**Item 9.****Development Application: 1-7 Wellington Street, Chippendale****File No.:** D/2018/313**Summary**

**Proposal Summary:** The application proposes alterations and additions to an existing two-storey commercial warehouse building for its adaptive re-use as commercial offices and cafe. Works consist of an additional third storey with solar panels above, facade improvements, new landscaped areas to the ground floor and second floor (third storey), internal alterations associated with the proposed commercial use, and end of journey facilities.

**Figure 25:** Shadow diagrams for 1pm, 2pm, and 3pm on June 21 (winter solstice)

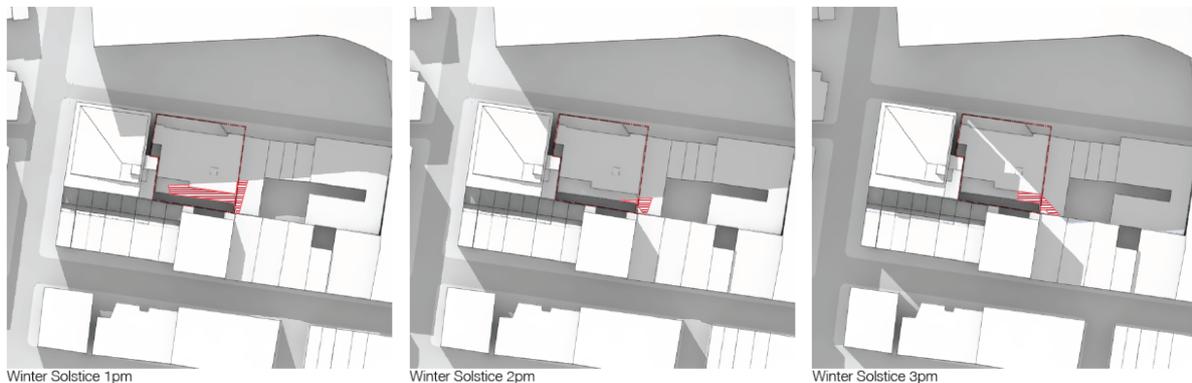
**Response** - The application has been reviewed by Council's Urban Design team, who have advised that the shadow diagrams and views to the sun prepared by the applicant are accurate, and that the proposal will result in minimal, if any, additional mid-winter overshadowing to properties to the south, with the greatest impact being to the commercial building to the east in the afternoon. See Figure 25 below.

Overall, the proposal is considered acceptable with regard to solar access, as it has been demonstrated that the additional storey will not cause adverse overshadowing impacts to nearby residential properties.

**Figure 27:** Proposed building envelope outlined in red, Block 11 SSD development building envelope in purple (currently under construction), as viewed from second floor of adjoining terrace, looking north

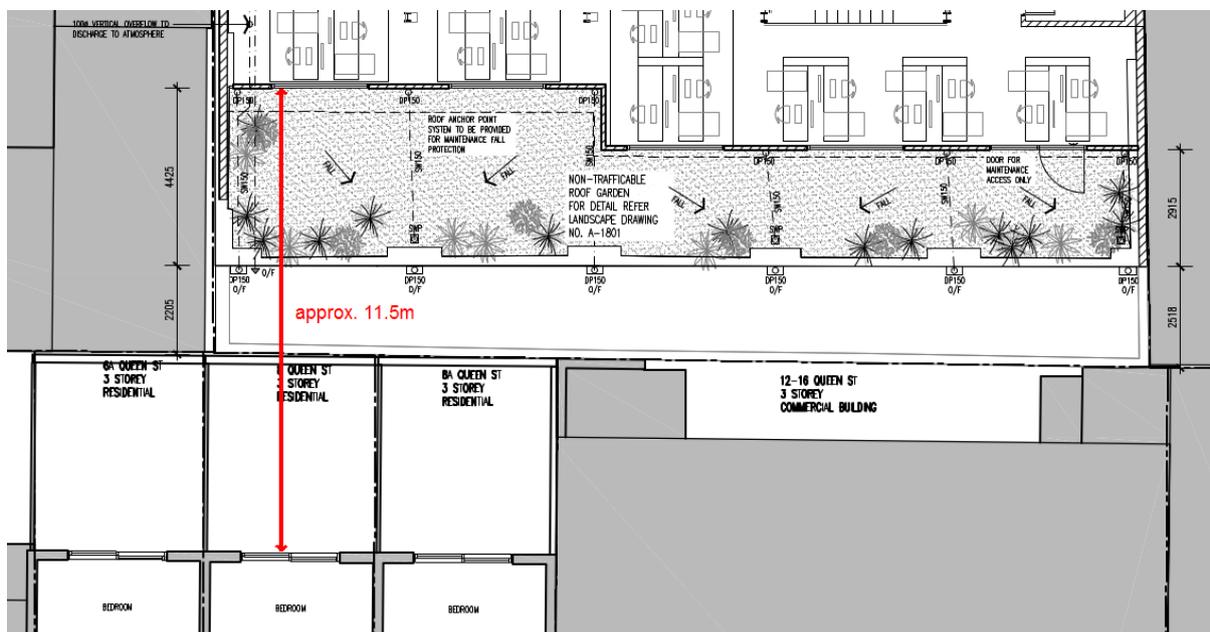
Supporting documentation provided by the applicant demonstrates that the proposal does not result in substantial loss of outlook, particularly with consideration to the multi-storey State Significant Development currently being constructed at Central Park (Block 11). See Figures 26 and 27 below, which depict the approximate extent of the proposed addition and its impacts on outlook from the south.

As demonstrated by the Figures above, the proposed addition will not result in considerable impacts to the outlook or sense of enclosure of the existing terrace dwellings to the south.

**Figure 29:** approximate distance between proposed third storey addition and existing third floor bedroom windows at adjacent residential dwellings

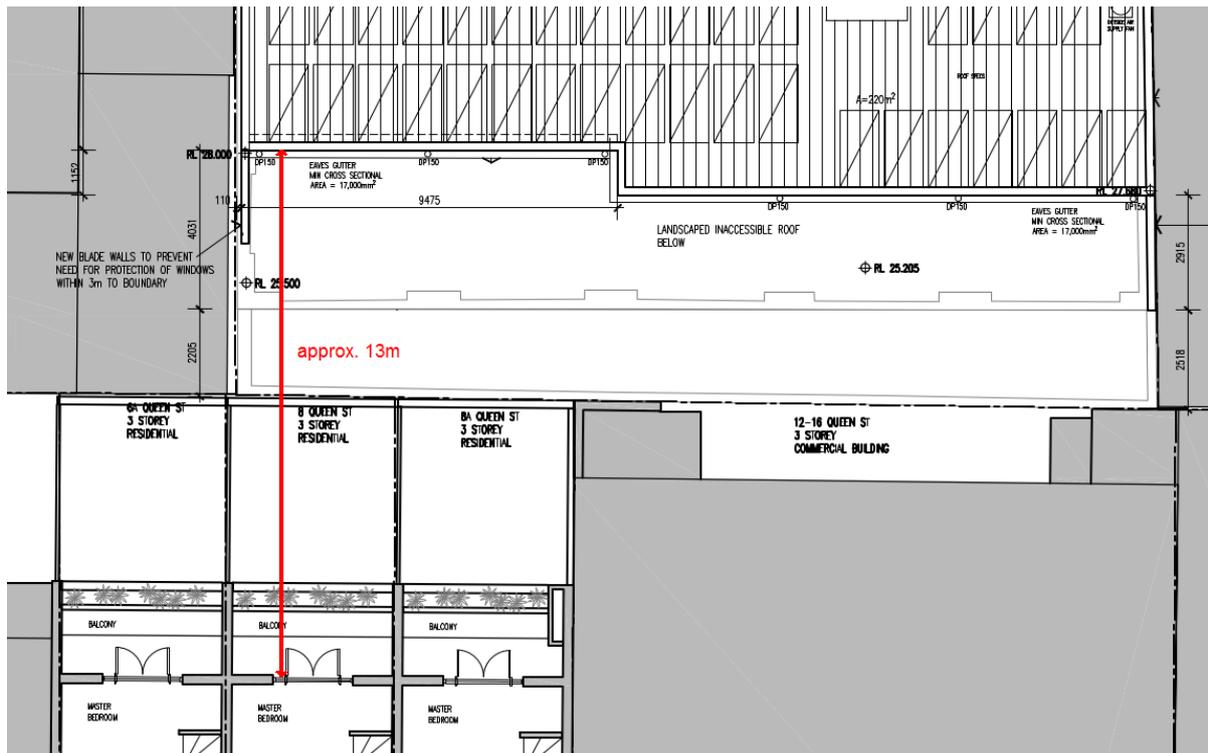
It is also noted that the second and third floor bedrooms of the terrace dwellings are located across a courtyard/balcony, and are considerably set back from the rear building line of the proposed third storey addition (approx. 11.5m for the second floor bedroom and approx. 13m for the third floor bedroom, which is located above the proposed addition with no direct line of sight to the rear windows of the subject development). See Figures 28 and 29 below.

These distances are considered to provide adequate separation between the existing residential terraces and the proposed third level addition, preserving visual privacy, and adequate natural light and ventilation to the terrace dwellings.
